Callaway Plant

ULNRC-06328

**DOCKET NUMBER 50-483
CALLAWAY PLANT UNIT 1
UNION ELECTRIC CO.
FACILITY OPERATING LICENSE NPF-30
REVISION OF TS 5.6.5, "CORE OPERATING LIMITS REPORT (COLR)," TO ALLOW
THE USE OF THE PARAGON AND NEXUS CORE DESIGN METHODS (LDCN 16-0011)**

LDCR 201606512

TABLE 4.3-7 ~~COMPARISON OF MEASURED AND CALCULATED DOPPLER DEFECTS~~ DELETED.

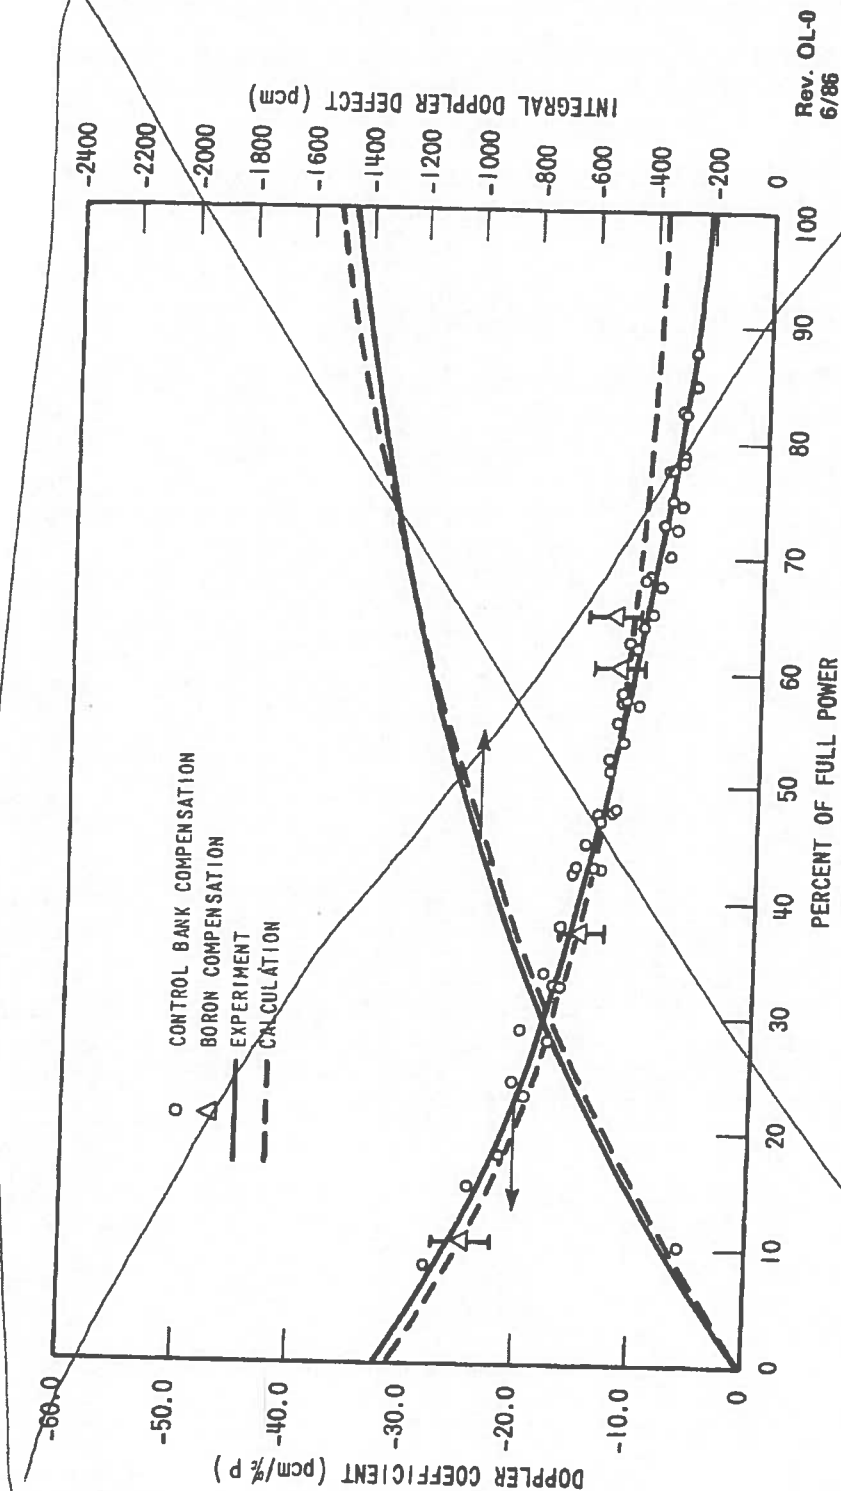
Delete
The temperature calculational model has been validated by plant Doppler defect data, as shown in **Table 4.3-7**, and Doppler coefficient data, as shown in **Figure 4.3-42**. Stability index measurements also provide a sensitive measure of the Doppler coefficient near full power (see **Section 4.3.2.7**). It can be seen that Doppler defect data is typically within 0.2 percent Δp of prediction.

FIGURE 4.3-42 HAS BEEN DELETED
